UNITED STATES PATENT AND TRADEMARK OFFICE

APPLICATION NO.	FILING DATE	FIRST NAMED INVENTOR	ATTORNEY DOCKET NO.	CONFIRMATION NO.
10/580,585	12/20/2006	Laurent Dubedout	291613US6PCT	5553

Office Action Summary	Application No. 10/580,585	Applicant(s) DUBEDOUT ET AL.	
	Examiner Robert Williams	Art Unit 4134

DETAILED ACTION

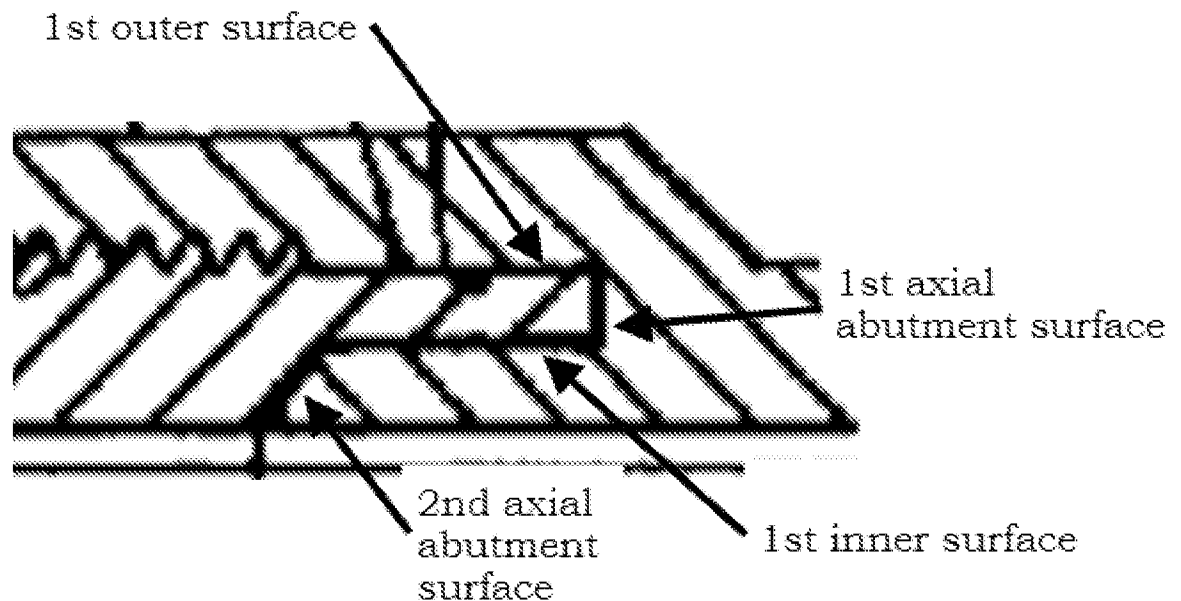
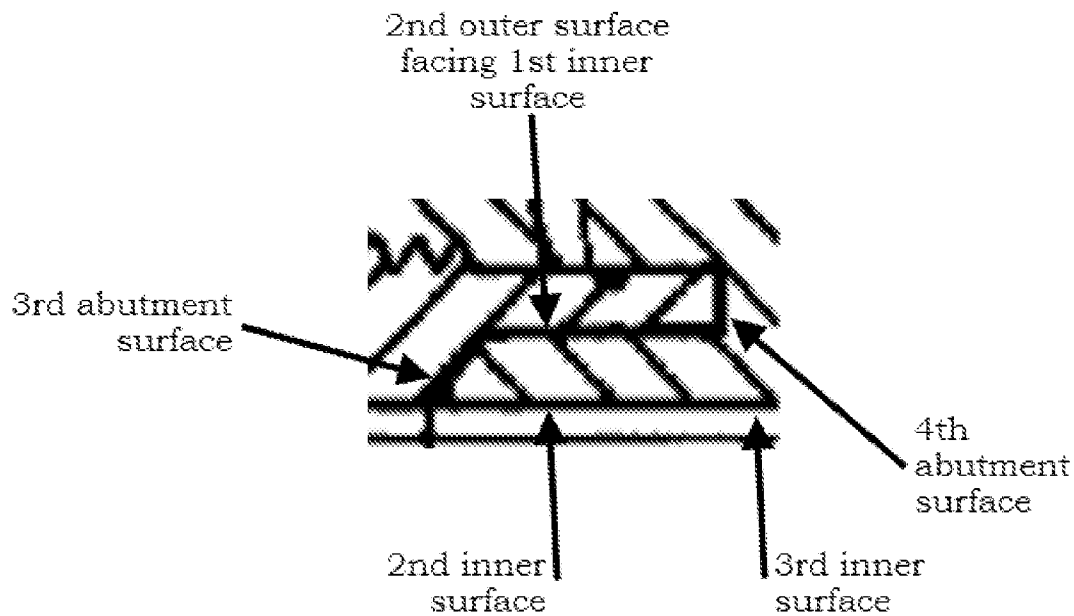
7. Metcalfe ‘947 discloses the claimed invention as follows:

- The claimed assembly of two expandable threaded tubular joints (page 8, lines 11-21, “The assembly ... allows lengths of expandable tubing to be connected to form a string, [and]

- comprises a tubular connector ... utilized to join the ends of two lengths of expandable tubing,” Fig. 2, #20, 21, 24, 25);
- The claimed first tubular element arranged at an end of a tube and comprising a first portion, provided with a male thread (page 9, line 3, “threads on the outer surface of the tubing,” Fig. 2 #24, 28);
 - The claimed second portion extending said first portion (page 9, lines 3-4, “Inwardly of the threads, the end portions,” Fig. 2 #20, 21);
 - The claimed second portion comprising a first outer surface, a first annular lip having a first axial abutment surface and a first inner surface and delimited by said first outer surface over a portion of the axial length thereof, and a second abutment surface (page 9, lines 5-6, “corresponding tongues provided on the ends of the tubing lengths,” Fig. 2 #32, and as shown below);

- The claimed second tubular element comprising a female thread, matching the first male thread and screwed thereto (page 9, lines 1-3, “inner walls of each connector end portion define threads for engaging corresponding threads on the outer surface of the tubing,” Fig. 2 #26, 27);
- The claimed second annular lip having a third abutment surface, a second outer surface, capable of being arranged to face said first inner surface, a second inner surface, a third inner surface and a fourth axial abutment surface (Fig. 2, as shown below);

- The claimed annular recess matching and receiving the corresponding first lip (page 9, lines 5-6, “grooves to receive corresponding tongues provided on the ends of the tubing lengths,” Fig. 2 #30, 31);
- The claimed female/female-type connection sleeve (page 8, tubular connector, Fig. 2 #16);
- The claimed central portion (page 8, lines 17-18, “intermediate portion,” Fig. 2 #22);
- The claimed annular zone having an initial reduced thickness (page 8, lines 26-28, “the connector end portions are upset, that is they include portions of greater wall thickness than the tubing and are of a greater diameter than the tubing,” Fig. 2);

- The claimed each second abutment surface rests against the corresponding third abutment surface and/or each abutment surface rests against the corresponding fourth abutment surface (Fig. 2, and as shown above); and
- The assembly of Metcalfe '947 is inherently capable of developing, after diametrical expansion in the plastic deformation region, sealing interference contacts sealing the assembly

12. Regarding Claim 4, Metcalfe '947, as applied to Claims 2 and 3 above, further discloses the claimed dish extends substantially in a zone between last threads of the two female threads, as shown in Figure 2.

13. Regarding Claim 5, Metcalfe '947, as applied to Claim 4 above, further discloses the claimed dish extends substantially between said third abutment surfaces of the two second tubular elements, as shown in Figure 2.
